City of Portland, Maine – Building or Use Permit Application 389 Congress Street, 04101, Tel: (207) 874-8703, FAX: 874-8716

BUILDING PERMIT REPORT

REASON FOR PERMIT: TO Construct a 24x32' attached garage.

CHECK-LIST AGAINST ZONING ORDINANCE

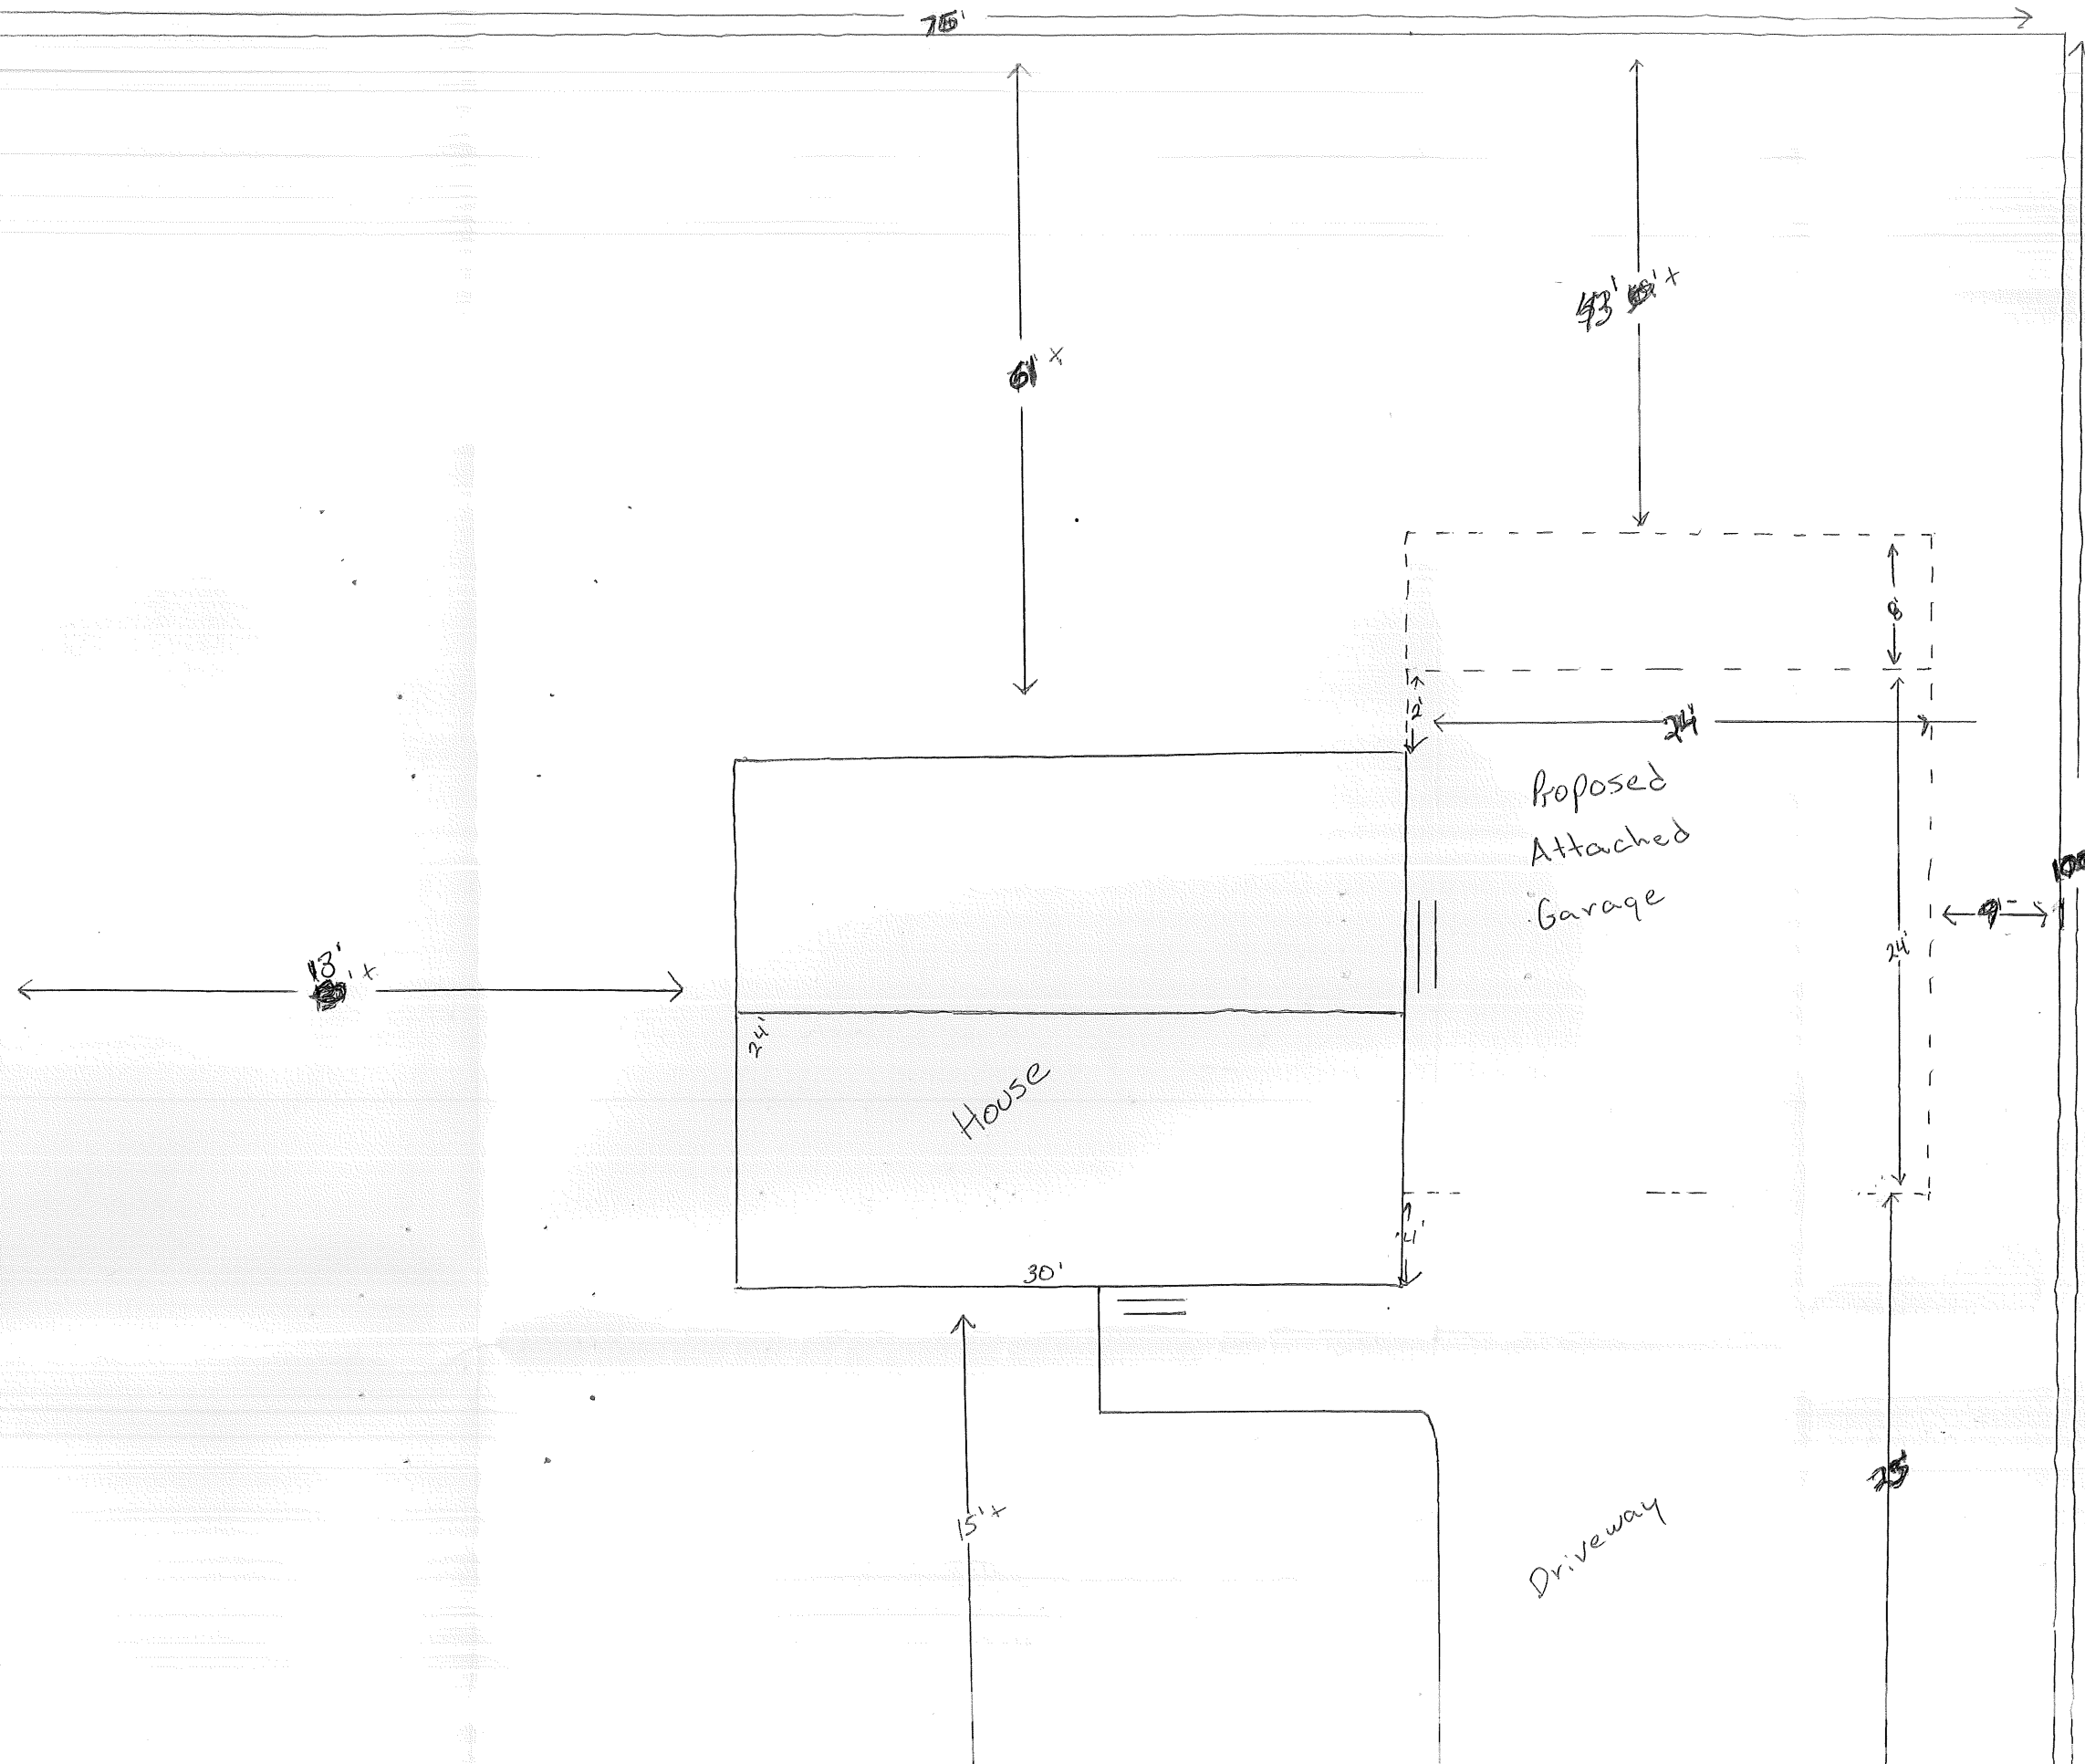
Front Yard - 25' req - 25' shown (no averaging)

Rear Yard - 25' req - 43' shown

Side Yard - 9' req - 9' shown

Lot Coverage/ Impervious Surface - 25% = 1875 sq ft max

26x32 = 832 sq ft
new 24x32 = 768 sq ft
1600 sq ft
